Part Number Update

Bulletin No: PNU-206

Subject: **Bendix Announces New Part Numbers for Bendix® TABS-6™ Standard Controller for Tank- or Frame-mounted Units**

Bendix® TABS-6™ Standard Controller (shown without connector cover installed)

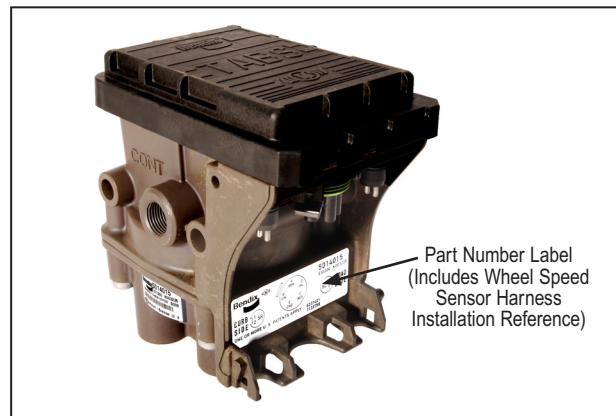
Trailer System	Old OE Part Number	Old AM Part Number	Crack-Pressure	New OE Part Number	Order New AM Part Number	New Controller Crack-Pressure
Two (2) Sensors, One (1) Modulator (2S/1M) Axle Systems Only	5014015	801855	3.0±0.5 psi	K109807	K109808	4.5±0.5 psi For improved brake balance performance. Additionally, Bendix® brand air disc brake applications no longer require a 3.3 psi crack-pressure quick-release valve.
Two (2) Sensors, One (1) Modulator (2S/1M) Dolly Axle Systems Only	5014112	801990	3.0±0.5 psi	K109809	K109812
